**FINAL REPORT**  
**INDEPENDENT ASSESSMENT PROGRAM**

**COMANCHE PEAK STEAM ELECTRIC STATION**  
**(PHASE 3)**

#### 4. 3-Sided Welds

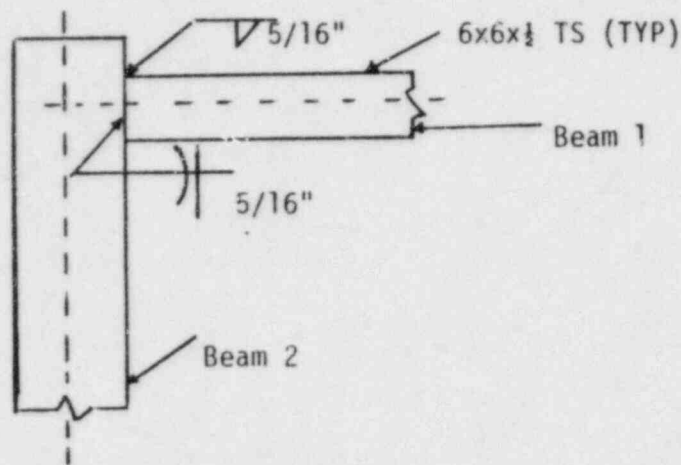
In certain connections, Cygna noted the use of 3-sided (see sketch) welds used to transfer the loads from one member to another. In most instances, the designer did not transfer the loads from the center of gravity of the beam (Point A) to the center of gravity of the weld (Point B). It is TUGCO's position that the designers use engineering judgment in determining if the effect will significantly impact design. That is, if the stress levels are low, the designer does not transfer the loads. For Cygna's assessment, see Observation PS-05.

## 6. Tubesteel Prying on Richmond Inserts

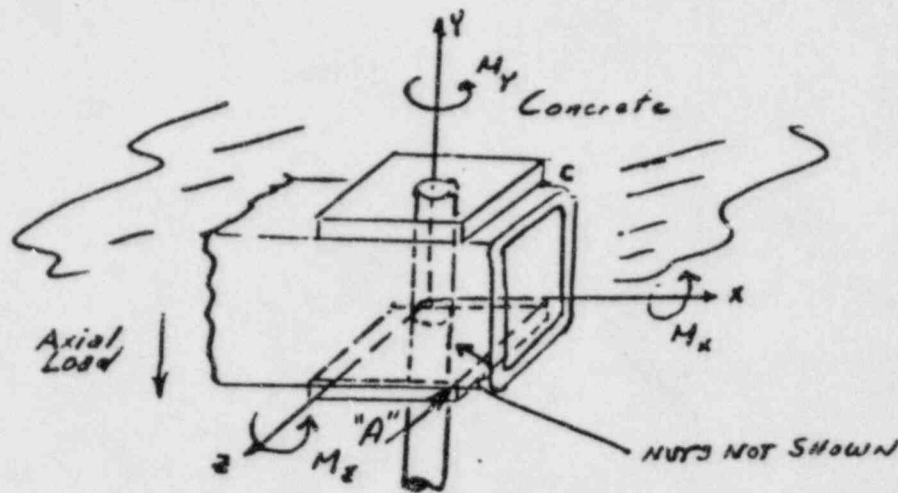
In the designs which employ tubesteel/Richmond insert combinations, Cygna noted that the engineer released the rotation about the Y and Z axes (see sketch) in the STRUDL model for the frame. While release of the Y rotation is appropriate since the bolt is free within the tube, release of the Z rotation assumes that the tube will not bear against the washer at point "A" and create a load due to prying on the bolt. TUGCO has provided justification for this and other analytical assumptions (i.e., the bolt does not carry any load in bending; the effect of bolt hole offset on bolt load) by performing both testing and analysis. Details of the justification may be found in the TUGCO letter dated 5/8/84 and in the "Affidavit of John C. Finneran, Jr., Robert C. Iotti and R. Peter Deubler Regarding Design of Richmond Inserts and their Application to Support Designs." In the letter to Cygna, TUGCO shows that prying due to rotation about the Z axis is not present when only vertical loads exist. When torsional moments ( $M_x$ ) exist, the study done by TUGCO shows that even with small amounts of torsion (1000 in-lb vs 40000 lb tension load), the effect of prying is due to torsion, with no contribution from moments about the Z axis. For large torsional loads (4000 in-lb vs. 2000 lb tension), the same effect holds true. Cygna then reviewed all tubesteel/Richmond insert joints within their scope and determined that the configuration analyzed by TUGCO (4 x 4 x 3/8 TS with 20" bolt spacing) is representative of the most flexible configurations and, therefore, most conservative. As a result, Cygna finds the method used by TUGCO to model these connections is acceptable.
